ISO/IEC 8802-11

AMENDMENT 4
2006-08-15

IEEE Std 802.11g-2003
(Amendment to
IEEE Std 802.11-1999)

AMENDMENT 4: Further Higher Data Rate Extension in the 2.4 GHz Band

Figure 27—Capability Information fixed field

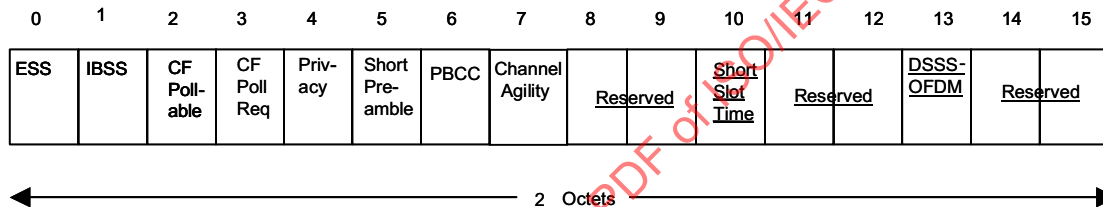
Replace Figure 27 with the following:

The length of the Capability Information field is 2 octets. The Capability Information field consists of the following subfields: ESS, IBSS, CF-Pollable, CF-Poll Request, Privacy, Short Preamble, Packet Binary Convolutional Code (PBCC), and Channel Agility, Short Slot Time, and DSSS-OFDM. The format of the Capability Information field is illustrated in Figure 27. No subfield is supplied for ERP as a STA supports ERP operation if it includes all of the Clause 19 mandatory rates in its supported rate set.
